Reference: Shell Service Station  
3790 Hopyard Road  
Pleasanton, California

Re: ADDENDUM TO WORK PLAN  
Shell Service Station  
3970 Hopyard Road  
Pleasanton, California

**Proposed Well Location Map**  
 Shell Service Station  
 3790 Hopyard Road  
 Pleasanton, California

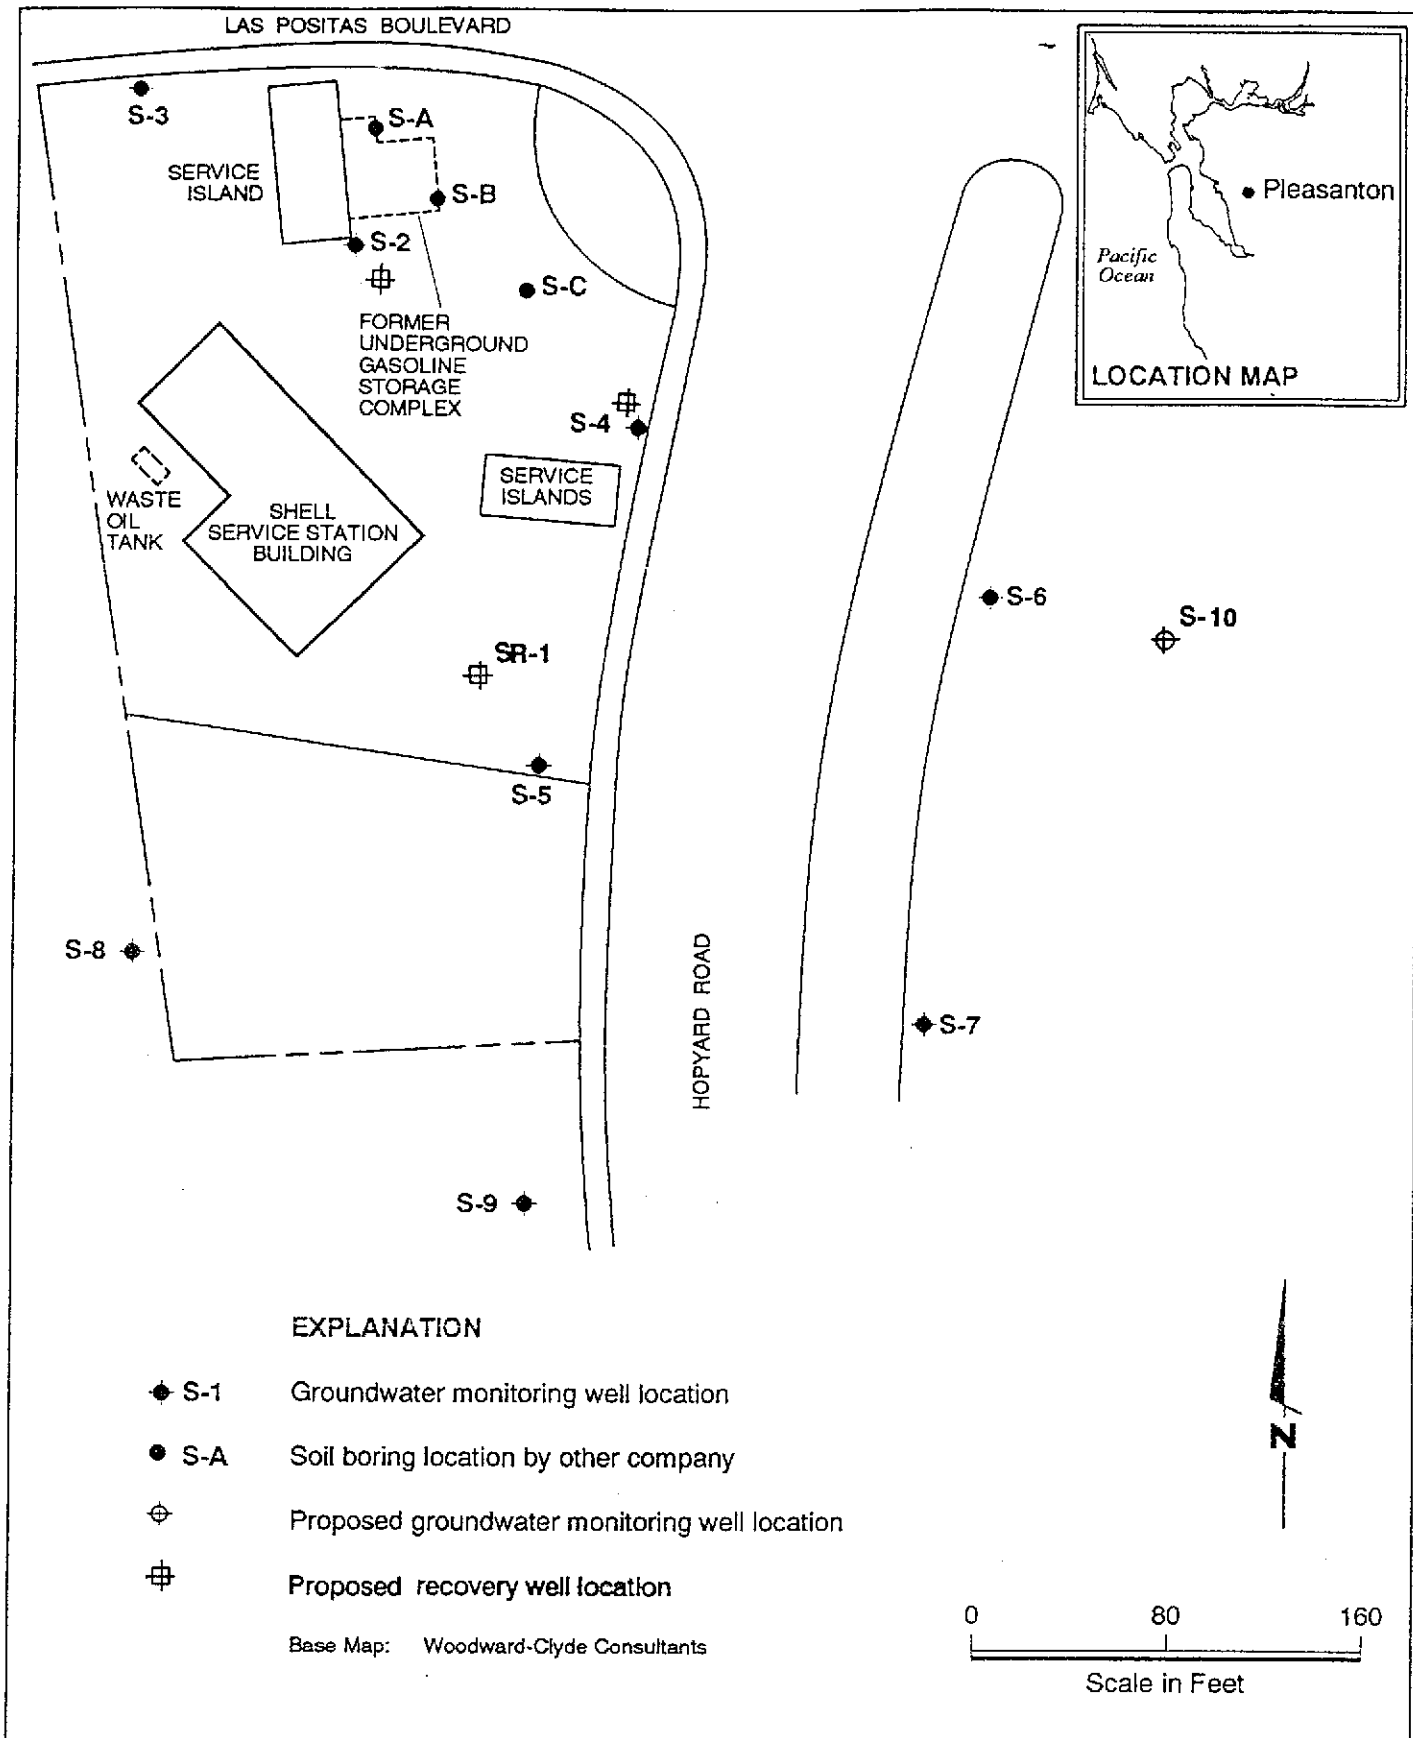
We recommend that the recovery system be designed to allow for the low yield of this aquifer. Three four-inch diameter wells, designed to the specifications described above, should be placed at the locations shown on the attached Plate 1. This will allow recovery to occur at two locations, which should provide more recovery per volume pumped given the sedimentology of the aquifer. The wells and the start-up procedure for the recovery wells will be done in accordance with the procedures attached to the work plan dated July 18, 1989.
